INITIAL FIRE SAFETY INSPECTION REPORT

SOUTHERN CLOTHINGS LIMITED (EXTENSION-2)

RSC ID: 25992

Date: 09 February 2025

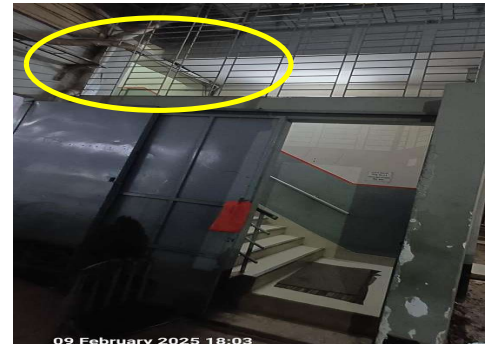
1	Means of Egress	Exit stairs are not separated from work areas & other spaces on each floor by fire-rated construction due to unprotected openings, penetrations. Electrical cable raceway is located on stair enclosure. Location: Building 2 (Wash Building).	Separate the exit stairs from work areas and other building spaces on all floor levels by minimum 2- hr. fire-rated construction. Provide a minimum 1.5- hr. fire-rated doors and seal all unprotected openings and penetrations to maintain the fire separation. Ensure that all fire doors are self-closing and positive latching, and are provided with fire exit (panic) hardware where serving production floors or assembly occupancies. If fire doors are required to be held open for functional reasons, provide automatic closing devices tied to the fire alarm system. Penetrations into and through an exit enclosure shall be prohibited with the exception of required exit doors, sprinkler piping, standpipes, electrical raceway for fire alarm equipment, and electrical conduit serving the exit enclosure.	Within 3 months

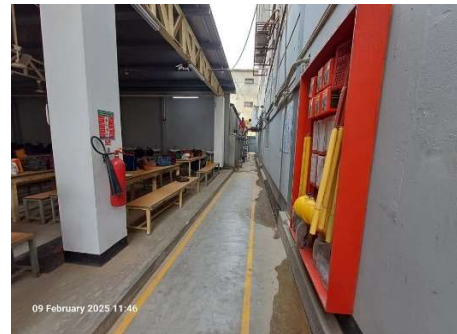
4	Fire Rated Construction	The required fire separation distance for Building-07 (Dining Shed) does not comply with the requirements of BNBC 2020.	The exterior walls shall have a fire resistance and opening protection as specified in BNBC 2020 Part 3 Table 3.2.2 & 3.2.3 and BNBC 2020 Part 3 Section 2.4.1.3.	Within 6 months

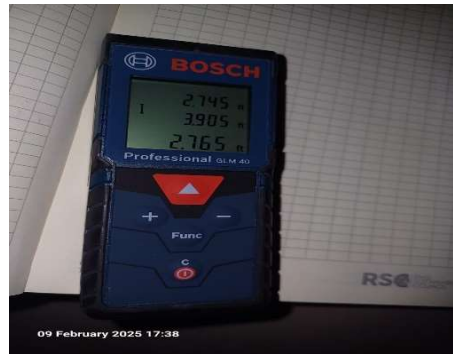
11	Means of Egress	Sliding doors are provided at exit discharge. Location: Discharge exit of 1st floor of Building 2.	Replace all collapsible gates/ sliding doors/ rolling shutter doors along the means of egress with side-hinged, swinging egress doors. If locks are required for security reasons, utilize specialized door locking features complying with NFPA101.	Within 1 month
